Sierra Club Comments on Desert Renewable Energy Conservation Plan EIR/EIS
Regarding Acreage Calculation and Determination of Need
February 23, 2015

Contact: Robert Freehling

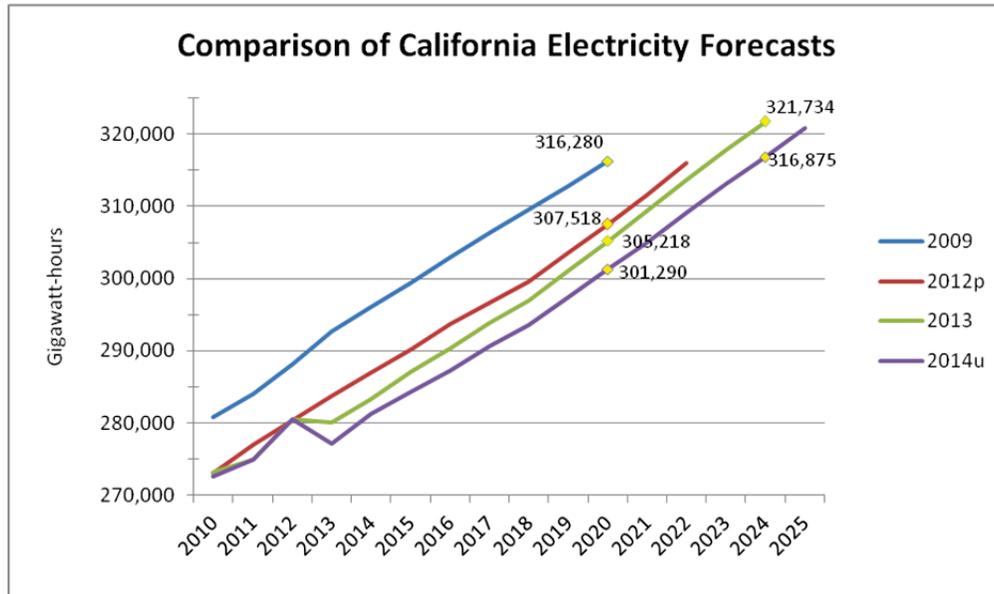
The following charts illustrate the systematic errors, due to the fact that every new Energy Commission forecast results in a significant reduction in projected future demand.

This chart also shows why it is important to use the most recent 2014 California Energy Demand Update (labeled 2014u) and why DRECP’s use of any of the previous forecasts is seriously obsolete. By 2020 the newest forecast is 4,000 gigawatt-hours lower than the 2013 forecast—which is where the draft DRECP narrative concludes—and the difference increases over time such that by 2024 the gap is 5,000 gigawatt-hours. The gap is even larger when measured against the 2012 preliminary forecast (2012p), which was the most recent available when the July 2012 update “scenario” was produced.

While some people may consider a 5,000 gigawatt-hour reduction to be a minor “tweak” to the demand forecast, some context can show why this is not correct. This reduced demand directly offsets the need for renewable energy generation to reach a given carbon target, since renewable energy and reduced demand are both zero carbon “resources.” This table shows that nearly 1700 megawatts of wind power would be avoided by a 5,000 gigawatt-hour decrease in demand, which also means needing 67,000 acres less for wind energy development.

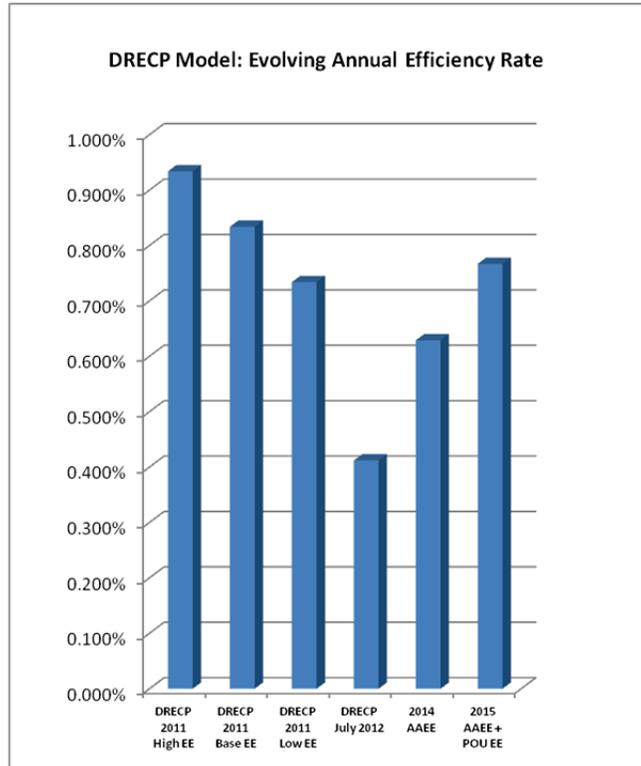
The table uses a similar method to the July 2012 revision of the DRECP model, which is to subtract embedded electric vehicles from the basic forecast, and then subtract the additional efficiency savings. However, this table is different in two important ways from the method used to date by DRECP:

1. The baseline value is total energy consumption rather than Net Energy for Load.
2. The table then subtracts POU additional efficiency

It is better to start with energy consumption because net energy for load is not a fundamental value. Net energy for load is actually a value in between total generation and total consumption. If you start with total generation, then it is necessary to subtract self-generation to get net energy for load. If you start with consumption, then it is necessary to add back line losses to get total generation, then subtract self-generation. Basically, net energy for load is what the utility has to produce or purchase from power generators after accounting for what people generate for themselves. The problem is that the growth of self-generation slows down the growth of (or may even shrink) utility-supplied electricity (net energy for load), compared to the actual total production of electricity—which equals utility generation plus self-generation by customers.

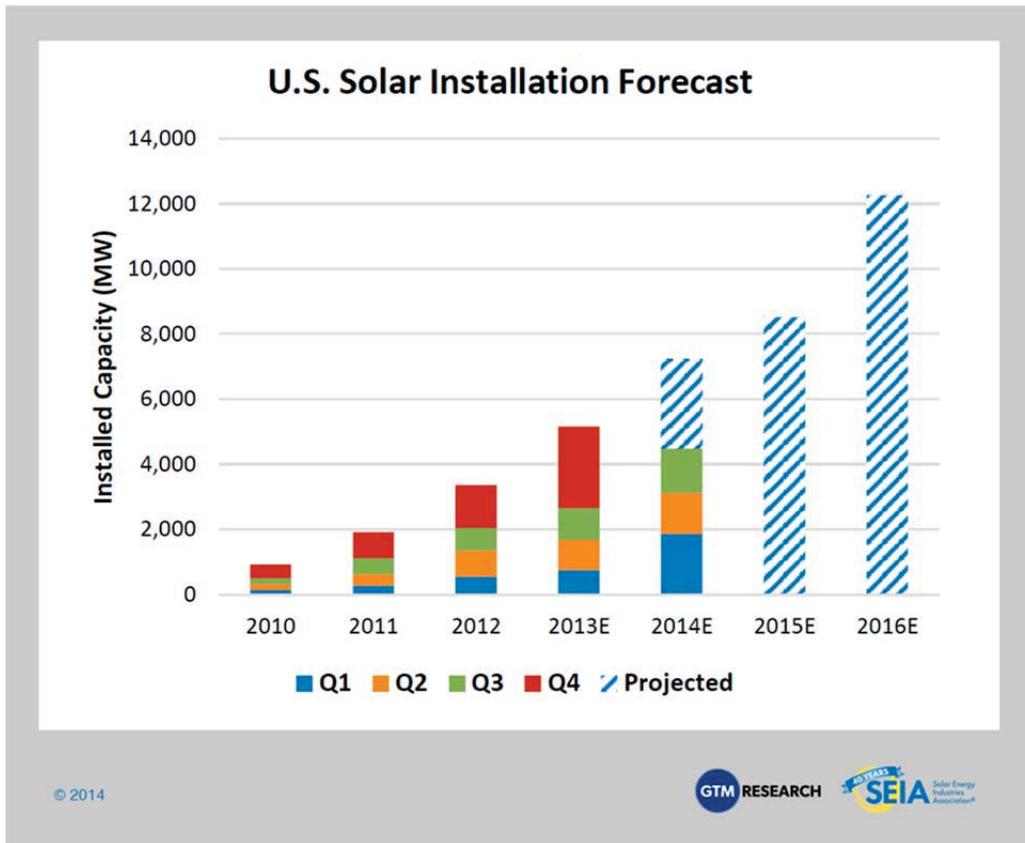
The unaccounted shrinking of the rooftop solar is not consistent with long-term trends for increasing utility rates and decreasing cost of solar PV. Furthermore, a simple visual inspection shows the inconsistent character of the trend line. The reduction in annual demand between 2013 and 2016 is probably accounted for by the Commission staff believing that the phase down of rebate rates from the Million Solar Roofs program would radically dampen demand for rooftop solar.

However, contrary to the Energy Commission, the solar industry (SEIA) and GTM Research are forecasting continued growth in the United States, with California being the largest market.³¹

Figure 11: PV investments cost projections in the hi-Res Scenario

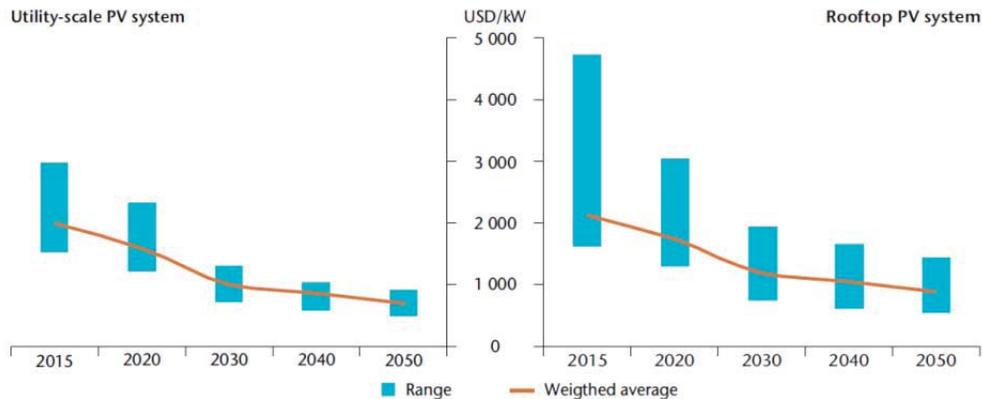
most of this loss. Reported costs in California were higher than average in the U.S at \$4.94,³³ suggesting an even larger possibility for price reduction, particularly since current installed costs of rooftop solar in Germany, Great Britain, and Australia are 40 to 50 percent lower than in California. Current forecasts by the International Energy Agency show rooftop solar photovoltaics decreasing dramatically in price at least out to 2050.³⁴

KEY POINT: The price ranges of PV systems will narrow, and the average cost will be halved by 2040 or before.

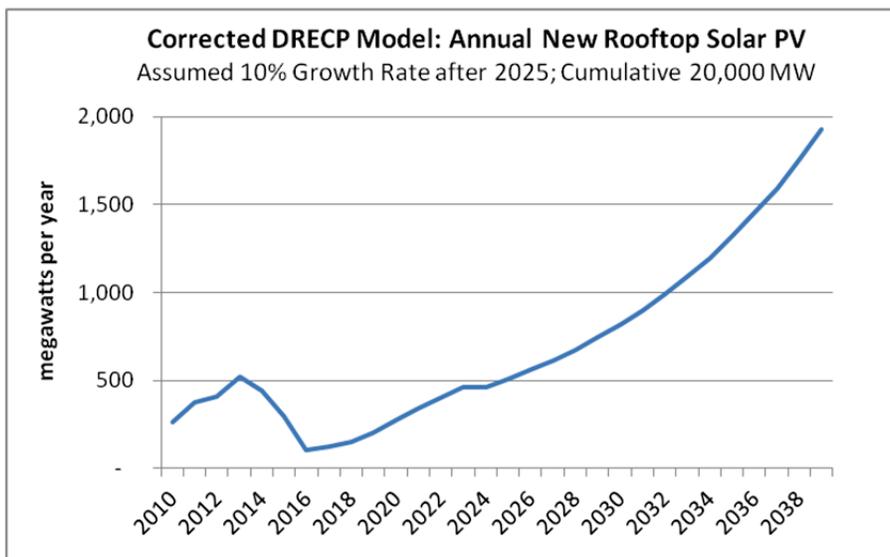
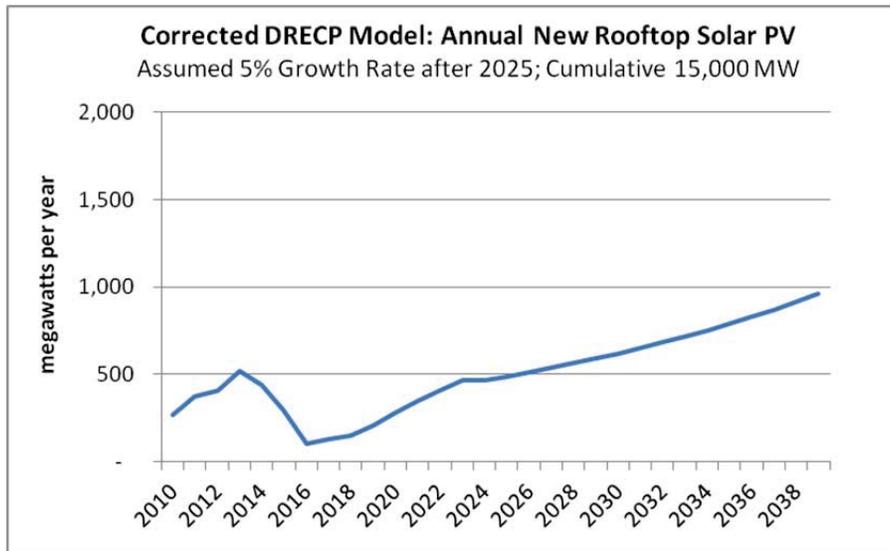
The chart of the above at 5% annual post-2025 growth clearly shows a slowing down of growth, while the chart below at 10% post-2025 growth is more consistent with the trend prior to 2025. Both of these single digit growth rates are much slower than has historically occurred, which can be seen by the comparatively steep angle at the left of the charts after 2010.
